Date: 10/01/2025

Project Number: 41-3097-25

Project Name: Ada War Memorial Park - New Concession Stand and Shelter House

Intent:

C300

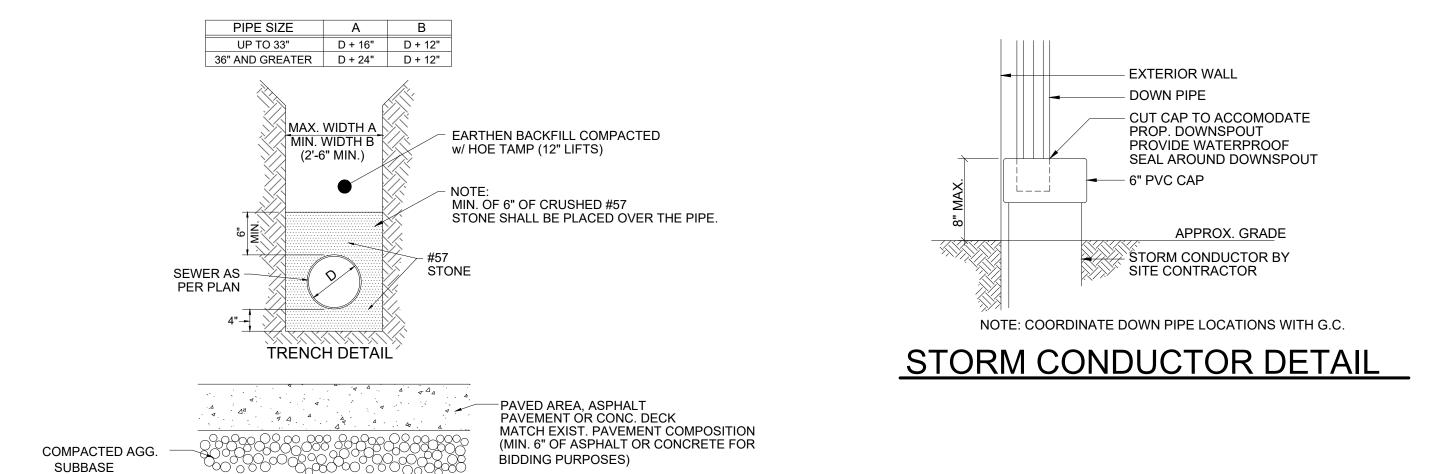
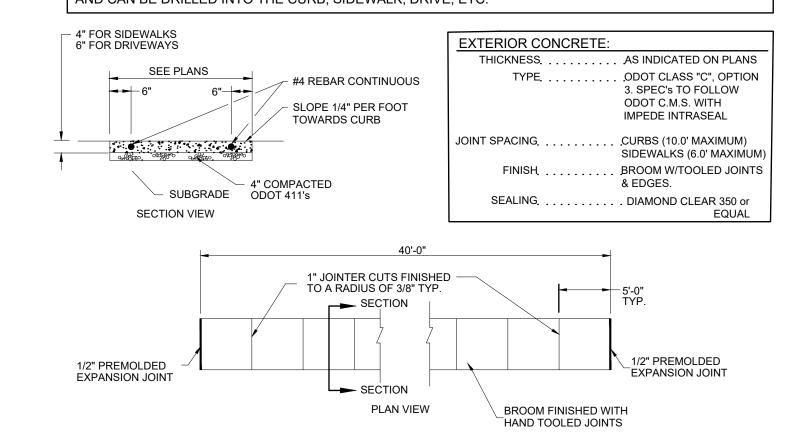
CONTRACTOR MAY USE PRECAST CATCH BASINS WITH KNOCK-OUT PANELS.

CONCRETE WALKS, DRIVES AND CURB RAMPS SHALL BE REINFORCED AND DOWELED INTO THE

TO CLARIFY, THIS APPLIES TO SIDEWALKS, DRIVE APRONS AND CURB RAMPS. THE REINFORCING SHALL BE A #4 REBAR MAT IN THE CENTER OF THE CAST-IN-PLACE SLAB AT MAXIMUM 4 FOOT ON CENTER AND ALSO THE DOWELS SHALL BE AT MAXIMUM 4 FOOT SPACING. THE DOWELS ALSO SHALL BE #4 REBAR AND CAN BE DRILLED INTO THE CURB, SIDEWALK, DRIVE, ETC.

SHEET A401

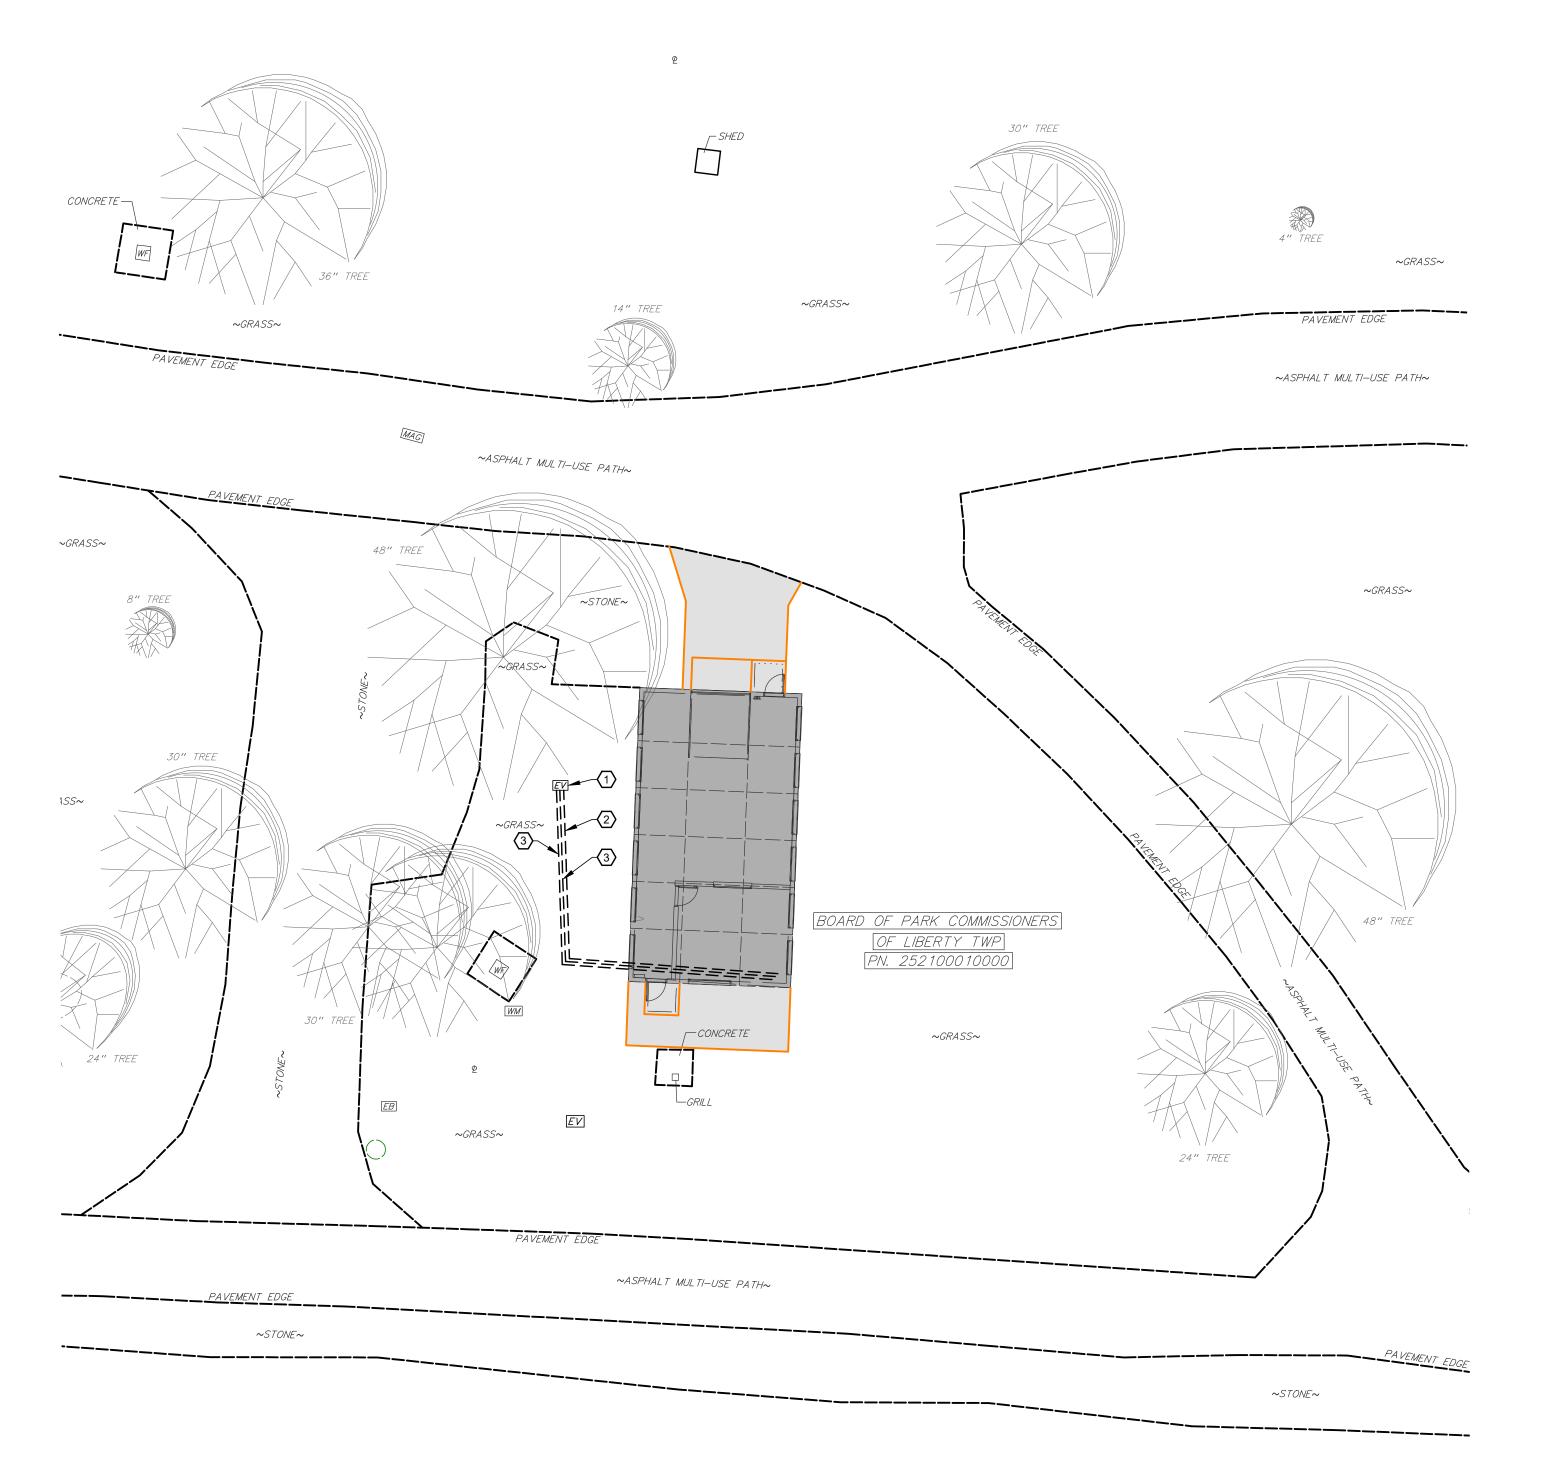
Item	Additional Document	Cons. Doc. Reference	Description
Specif	ications:		
1	APPROVED SUBSTITUTION		ADD AS AN APPROVED EQUAL: De La Fontaine to Hollow Metal Doors and Frames Specification.
2		081113 HOLLOW METAL DOORS AND FRAMES	ADD AS AN APPROVED EQUAL: Dimensional Metals, Inc. (DMI), Metal Panel Systems.
Civil:			
3	ISSUE DRAWING SHEETS C100,C101, & C300		ISSUE: Drawing Sheets C100, C1012 and C300 for the Concession Stand.
4	ISSUE DRAWING SHEETS C100, C101, & C300		<b>ISSUE:</b> Drawing Sheets C100, C101, and C300 for the Shelter House.
Archite	ectural:		
5	REISSUE SHEETS A-1 AND A-3		REISSUE SHEETS A-1 AND A-3 FOR THE SHELTER HOUSE: Added notes for inclusion of (2) 6" PVC sleeves (capped) through the wall of the shelter house.
6	REISSUE SHEETS A-1 AND A401		REISSUE SHEET A-1 FOR THE SHELTER HOUSE AND A401 FOR THE CONCESSION STAND: Door hardware set #1 has been revised. The concealed overhead stop has been replaced with a surface mounted overhead stop. A closer has been included in the door hardware.

SHEET **E101**

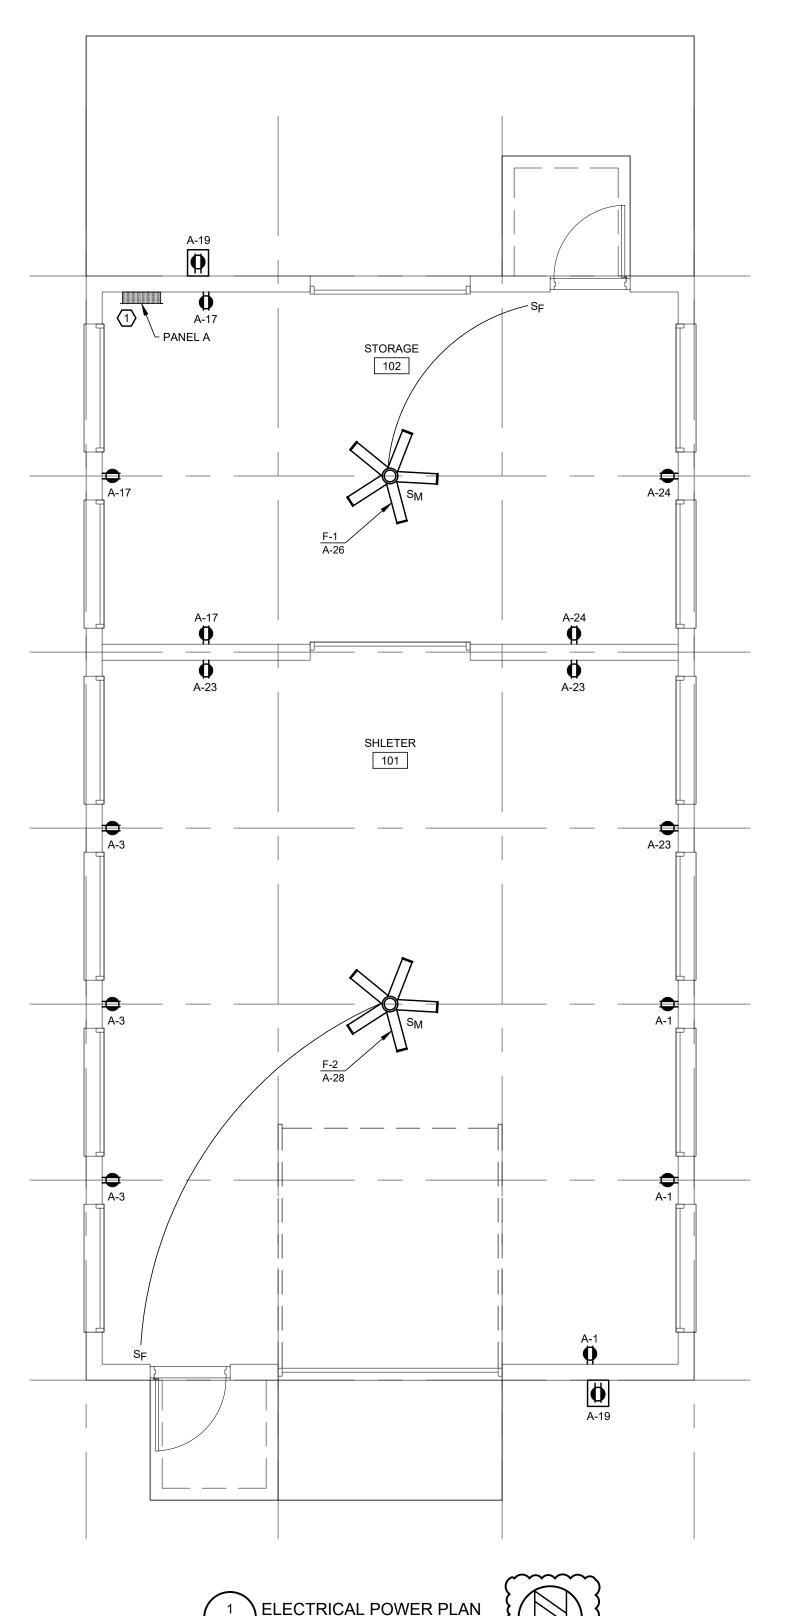
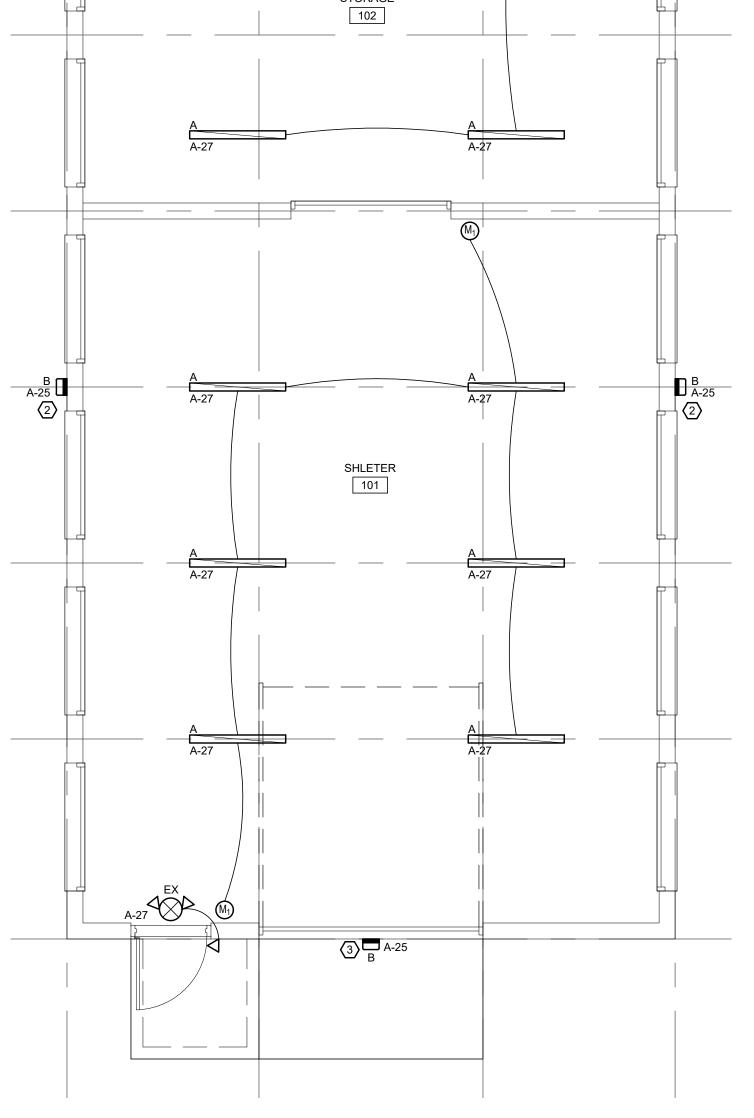
Electri	Electrical:					
7	ISSUE ELECTRICAL SITE PLAN E100		ISSUE: Sheet E100 for the shelter house.			
8	REISSUE DRAWING SHEET E101		REVISED FOR THE SHELTER HOUSE: Change rotation of North arrow. Added emergency light in Storage 102. Changed occupancy sensor to single pole switch in Storage 102.			
9	REISSUE DRAWING SHEET E501		REVISED FOR THE SHELTER HOUSE: Added LED emergency fixture to light fixture schedule. Added single pole switch to Lighting Legend.			
End of	End of Addendum 02
